**Attachment 4**

**Millstone Nuclear Power Station, Unit No. 3**

**Technical Specifications Change Request 3-11-00  
Reactor Coolant System Heatup and Cooldown Curves  
Retyped Pages**

**Millstone 3 Reactor Coolant System  
Heatup Limitations for Fluence up to 1.97E+19 n/cm (32 EFY)**

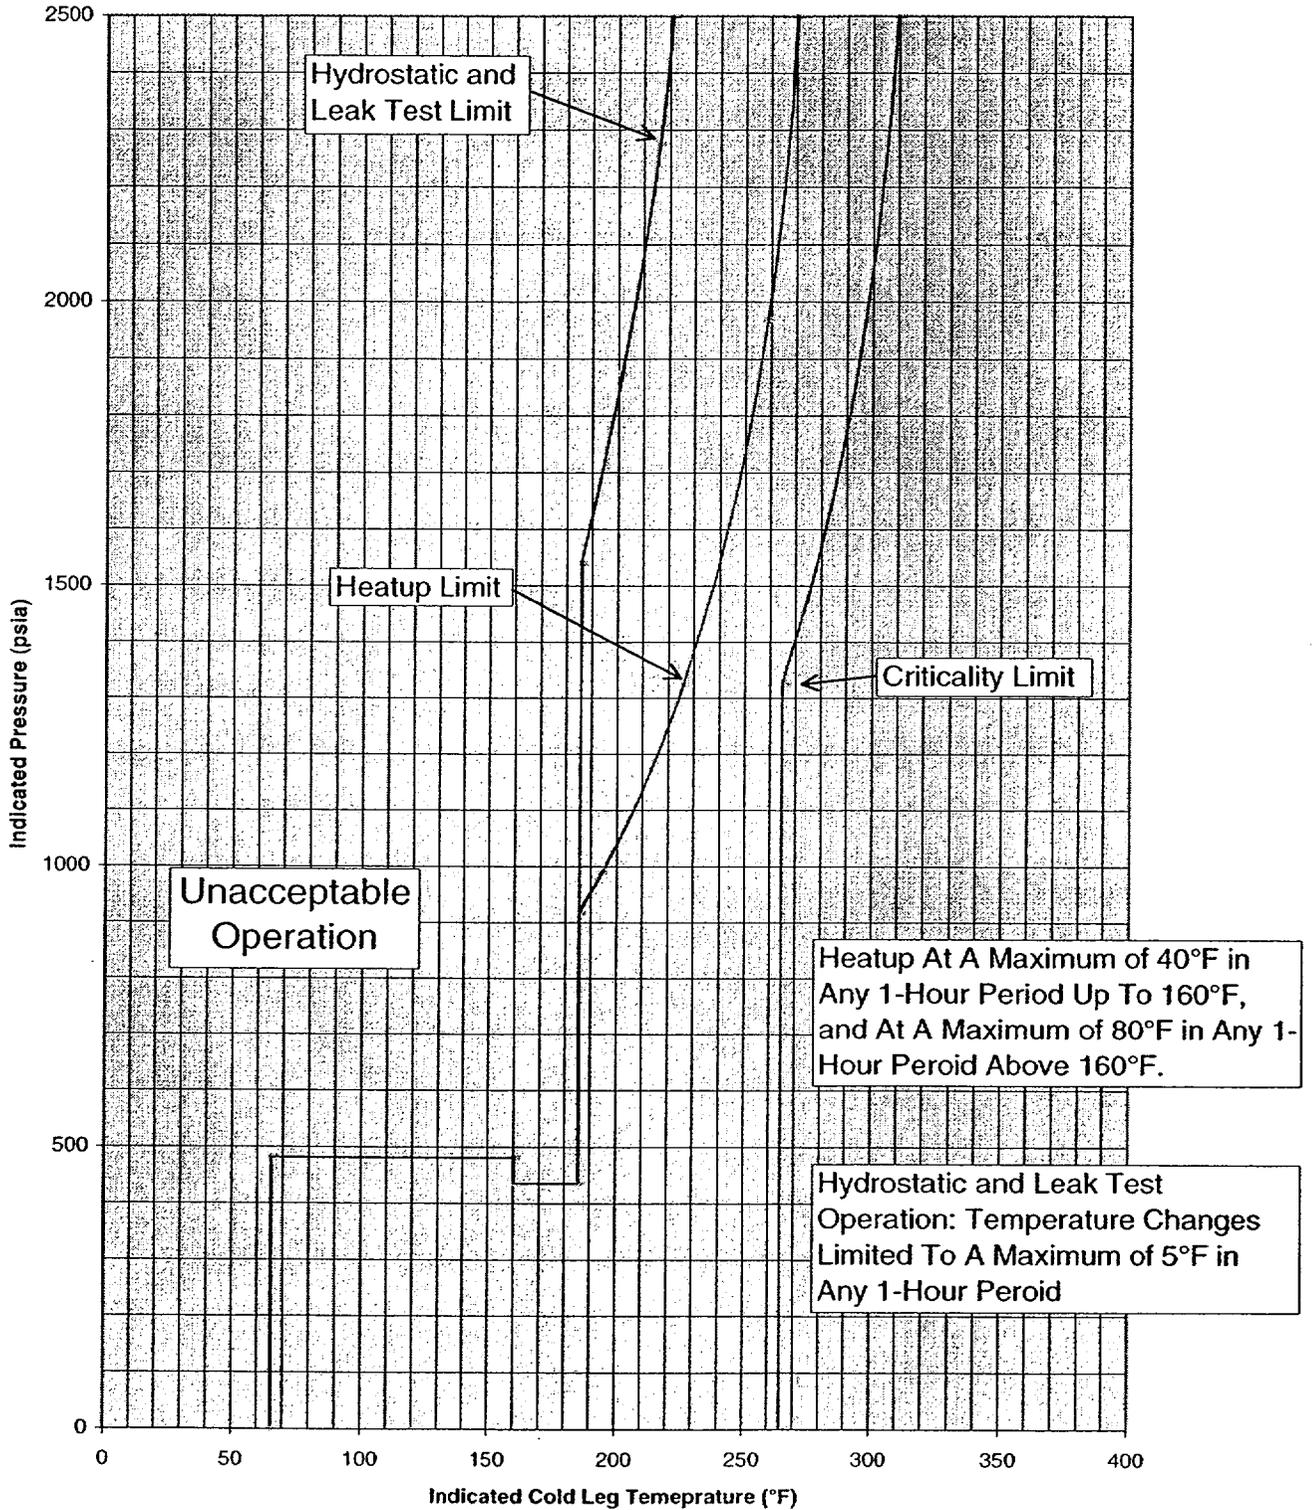
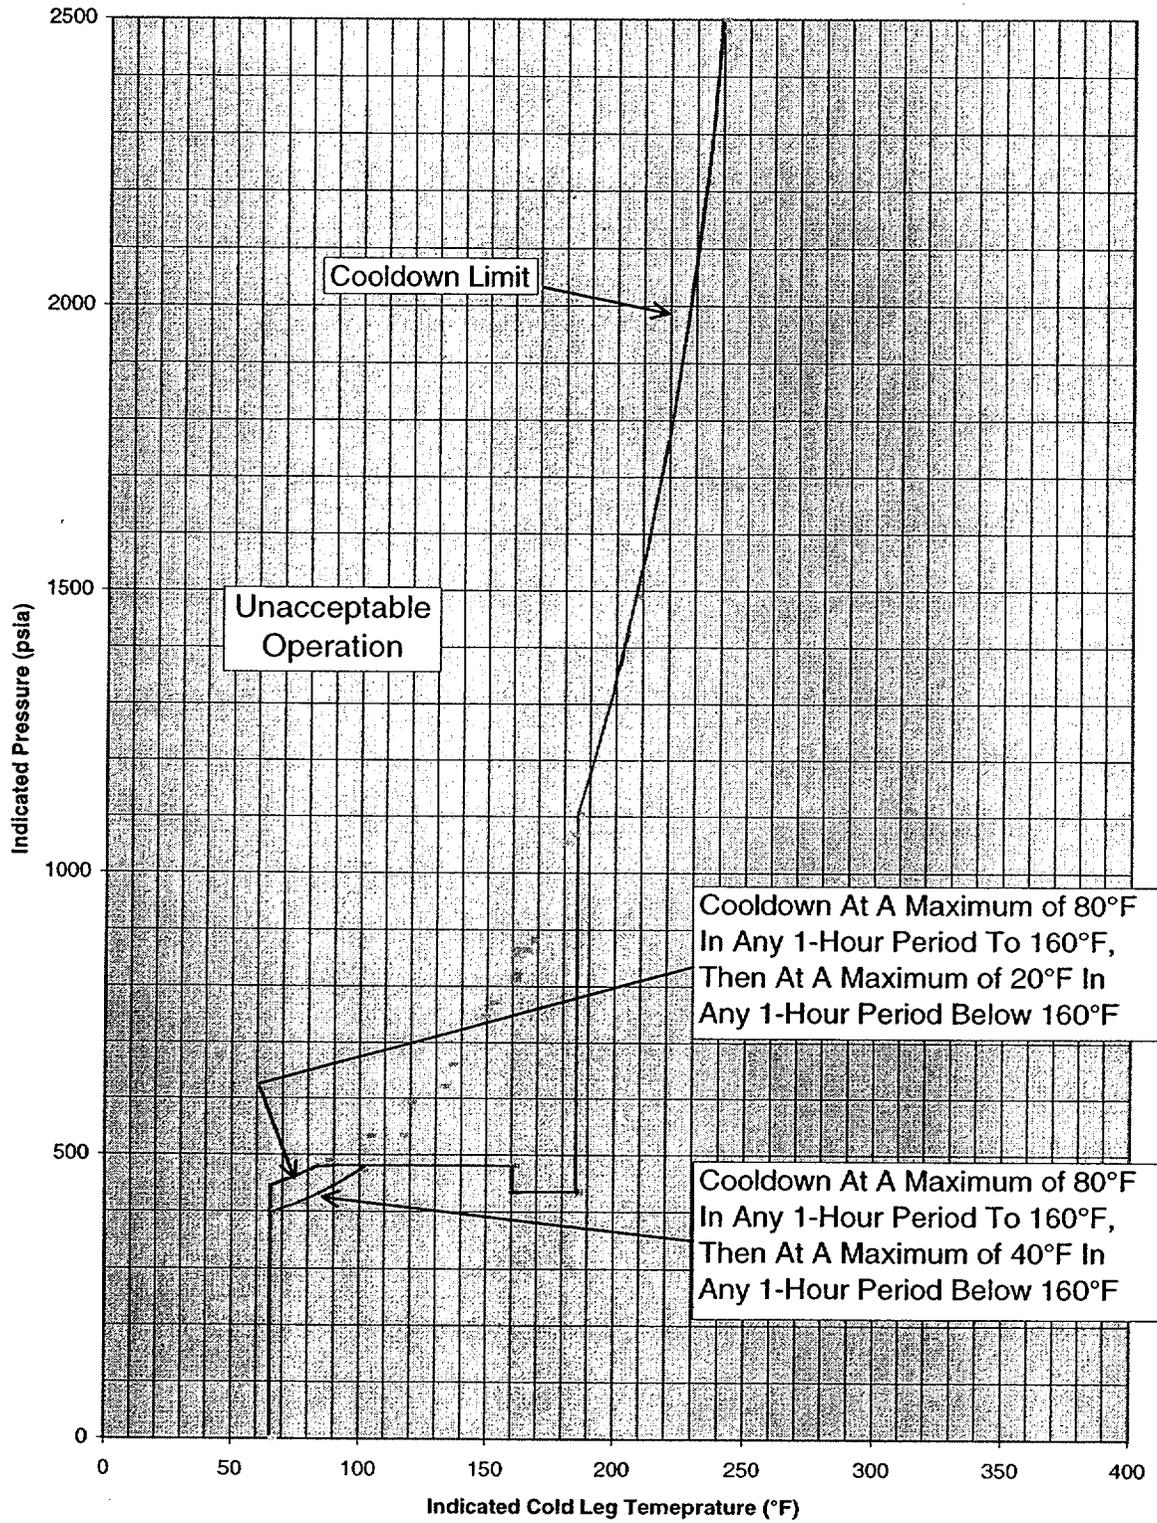
EFPY was chosen as the basis for the proposed heatup and cooldown limitations. Consistent with the current curves and current licensing basis, Regulatory Guide 1.99, Rev. 2,<sup>(4)</sup> was used to predict the beltline material degradation. However, the development of the beltline P/T limits was established using ASME Section XI, Appendix G, as modified by ASME Code Case N-640. This code case, which is not currently endorsed for use by the NRC in the regulations, provides an alternate reference fracture toughness curve ( $K_{IC}$ ) for establishment of the beltline P/T limits. The additional requirements of 10 CFR 50 Appendix G were considered in the establishment of the P/T limits. Clarification regarding applicability of P/T limits to ferritic materials was also provided. The proposed changes result in less restrictive P/T limits.

Figures 3.4-2 and 3.4-3 contain P/T limit curves for heatup, cooldown, inservice leak and hydrostatic (ISLH) testing, and data for the maximum rate of change of reactor coolant temperature.

# High Setpoint PORV Curve For the Cold Overpressure Protection System

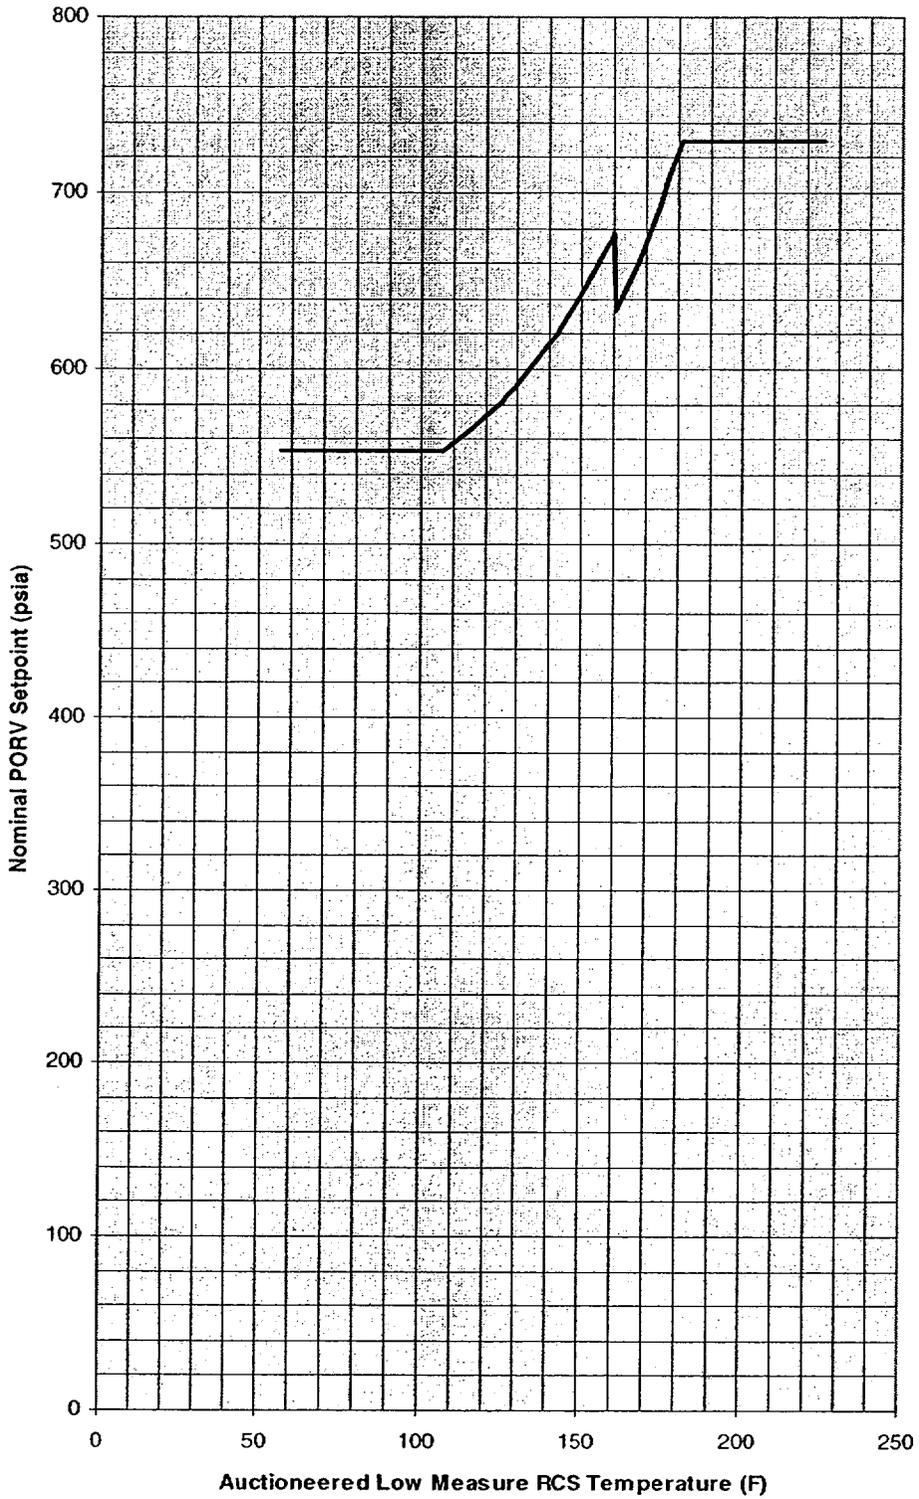
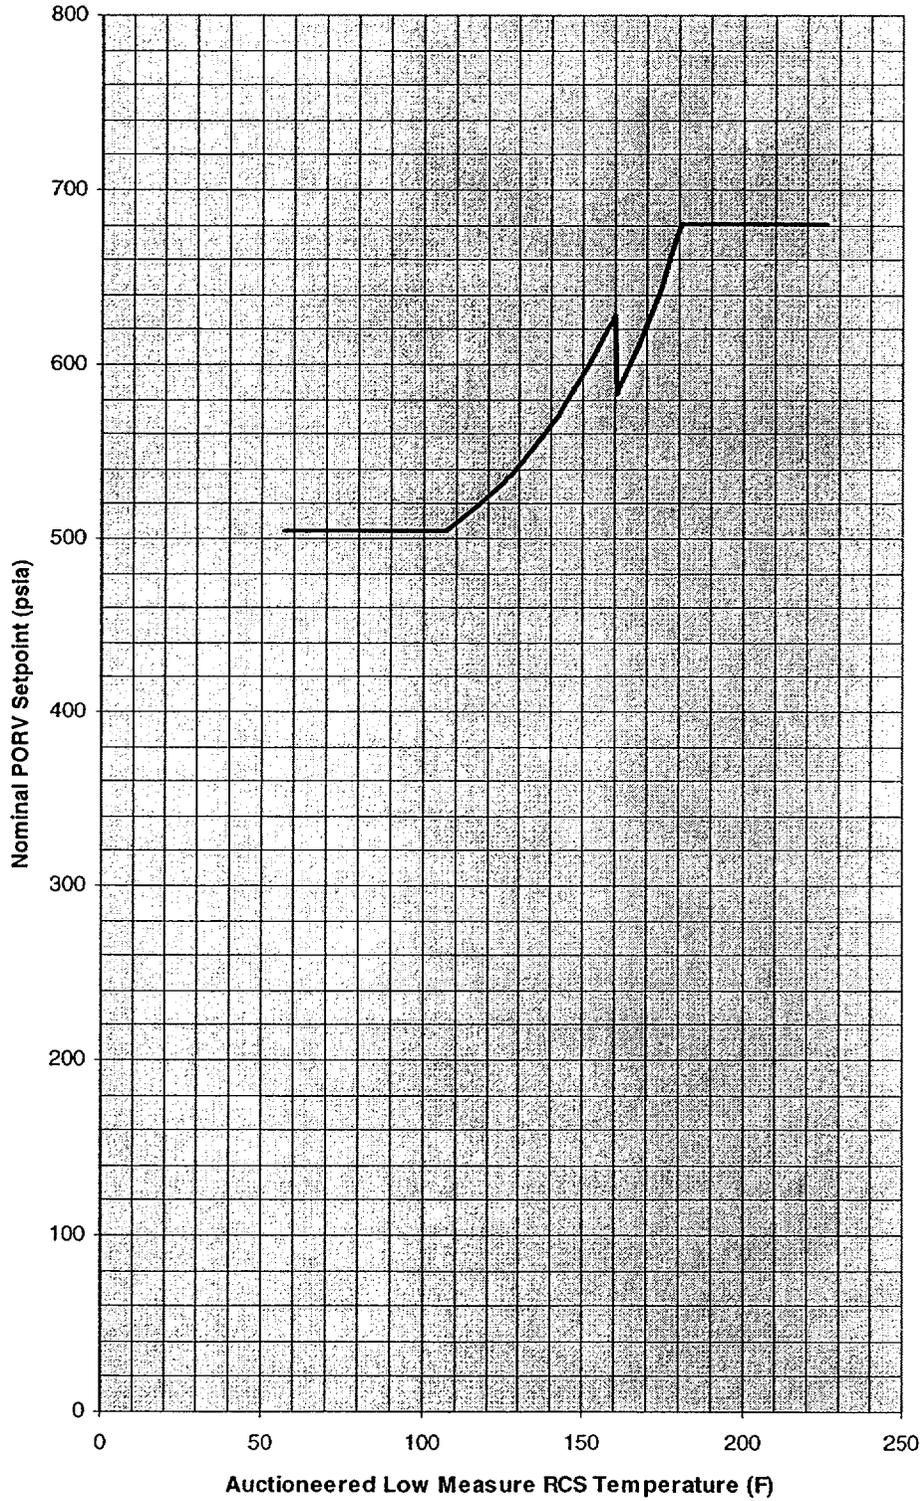
Directly related to the P/T limits are the COPPS requirements. The current COPPS (also referred to as low temperature overpressure protection or LTOP) setpoint curves are affected since the basis for the setpoint curves, the isothermal beltline P/T limit, has been modified. The setpoint curves were established to ensure the applicable limit would not be exceeded by placing operational restrictions consistent with the COPPS analyses assumptions.

Figure 3.4-4a and Figure 3.4-4b present the PORV setpoints for COPPS. The setpoints are staggered so only one valve opens during a low temperature overpressure transient. Setting both valves to the values of Figure 3.4-4a and Figure 3.4-4b within the tolerance allowed for the calibration accuracy, ensures that the isothermal P/T limits will not be exceeded for the analyzed isothermal events.
